## 29 New End, London NW3 1JD

I am writing in response to the basement impact assessment audit recently completed by CampbellReith, to provide clarification of points that are made in the hydrogeology and hydrology section of the BIA for 29 New End, London NW3 1JD.

Figure 1 Constant head test results

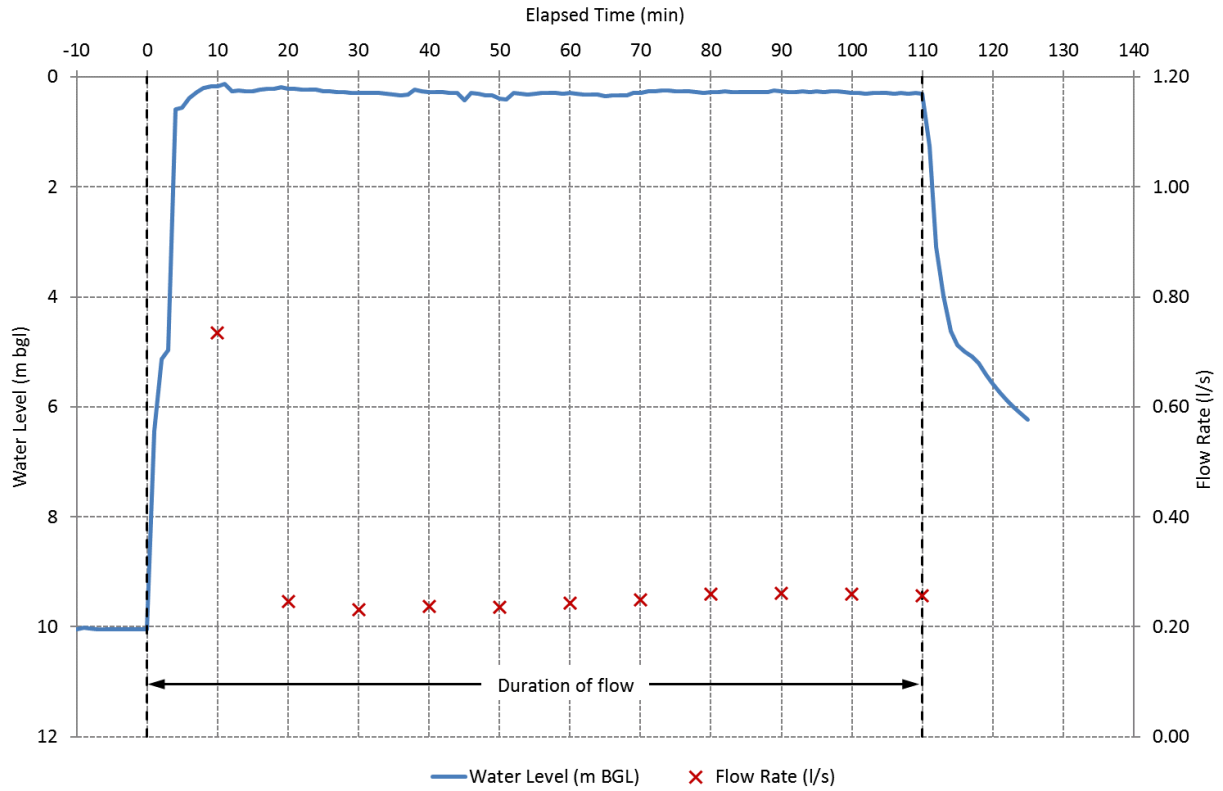
In March 2016, a constant head test was undertaken on BH102 to assess whether the deep aquifer was likely to be able to accept sufficient water to make it useful for a soakaway discharge. BH102 was chosen for this test because: where it intercepts the lower aquifer, the aquifer is more sandy than silty; it is better to discharge water in the back garden to get a higher head on the soakaway; and it is relatively far from the pavement vaults at 10, 12 and 14 New End.

In this test a constant flow rate of 0.25 l/s, when applied to BH102, maintained a constant head at close to ground level. Test data collected is shown in Figure 1. No other groundwater levels were monitored.

Figure 2 Modelled constant head test results

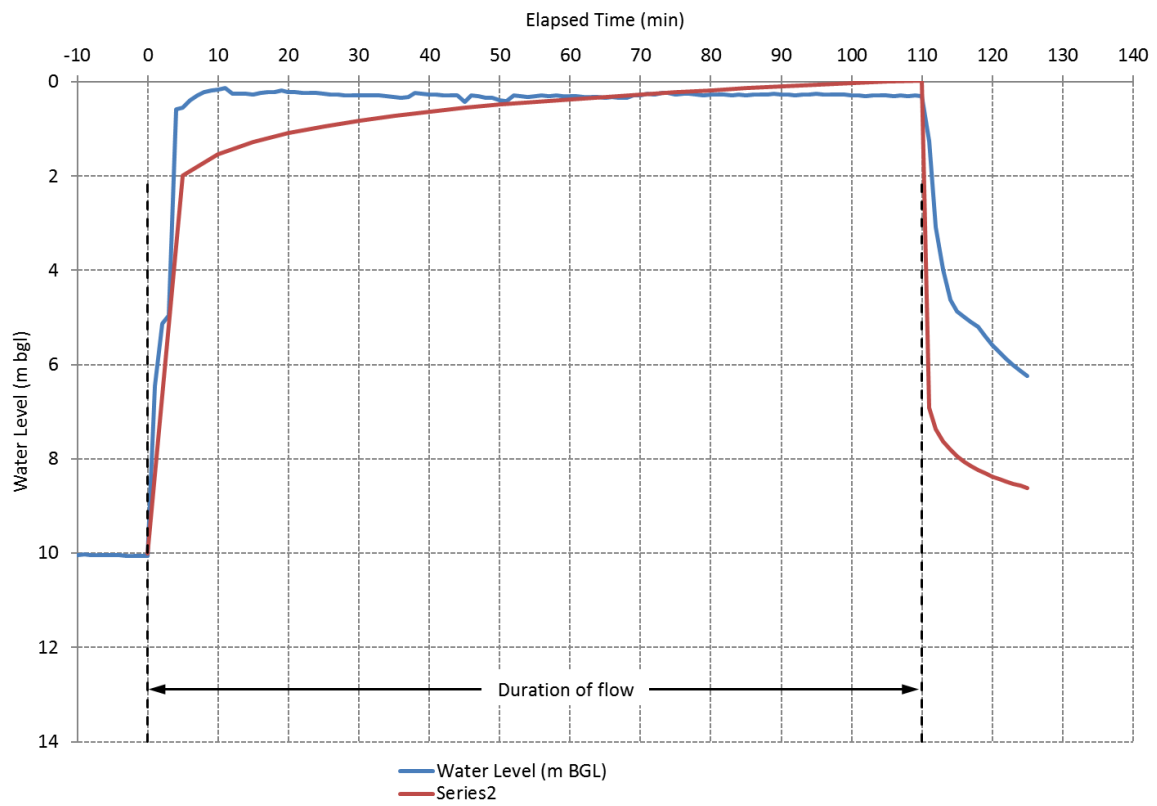
**Item 4.11 requests 1) a discussion of how the basement will intercept the discharge through the upper aquifer, and 2) a review of the potential impacts of the proposed soakaway discharge to the deep aquifer.**

A radial flow model, using the Theis equation, of the rise in groundwater level ('draw-up') has been developed for the deep aquifer (Figure 2). It has been calibrated to match the result of the constant head test, cited above, and the following parameters are suggested: transmissivity of  $2.6 \text{ m}^2/\text{day}$  for a storage coefficient of  $10^{-5}$ . The model is intended only to demonstrate a rough fit, as there are more complexities in this situation than described in the simple Theis equation: one key observation is that the draw-up very quickly stabilised; so in the aquifer there must have been a discharge boundary condition (perhaps into road drainage, granular fill in pipe trenches, or downwards into a lower aquifer).

This model can be used to estimate the rise of groundwater level at 69 m from the discharge – which is the distance from BH102 to the pavement outside 10, 12 and 14 New End. After 110 minutes (the duration of the test) the modelled rise is expected to have been 1.5 m. After 12.75 hours (the longest duration of the 100 year storm that would lead to a discharge of 0.25 l/s) the modelled rise is 2.7 m. (This is expected to be an upper estimate as the head in the soakaway will have been stable for all that time, rather than rising as predicted by the model.)
